EXHIBIT 1

Application/Control Number: 10/591,298
Art Unit: 4125

DETAILED ACTION

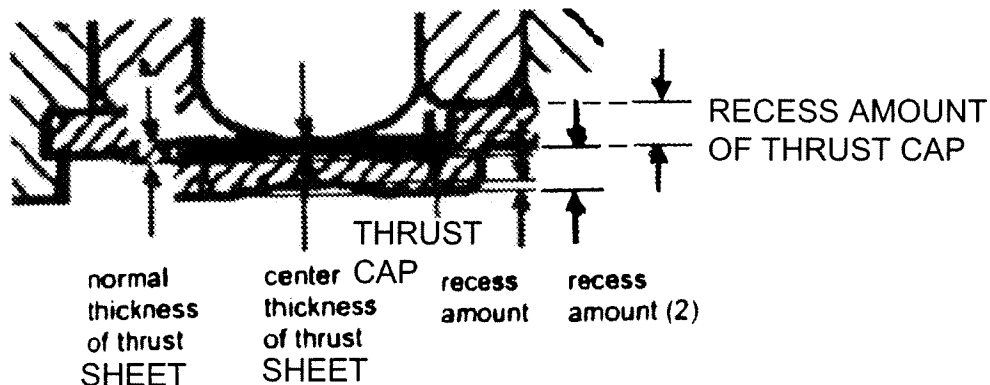
Line 26-29, page 3 recites "... a thrust sheet which is thinner than a recess amount of the thrust cap is provided between the thrust cap and the shaft". However, Fig. 1 shows the thickness of thrust sheet (even if compared to the thickness at center) is thicker than recess amount (see sketch below). If the 'recess amount' indicates 'recess amount (2)' as shown in sketch below, the thrust sheet can be thinner than the recess amount.

The thickness of thrust sheet mentioned in the same sentence above is not uniform according to Fig. 1. Therefore, it is not clear which portion of the sheet is referred for comparison. The examiner understands the thickness at the center portion is of interest. Appropriate correction is required.
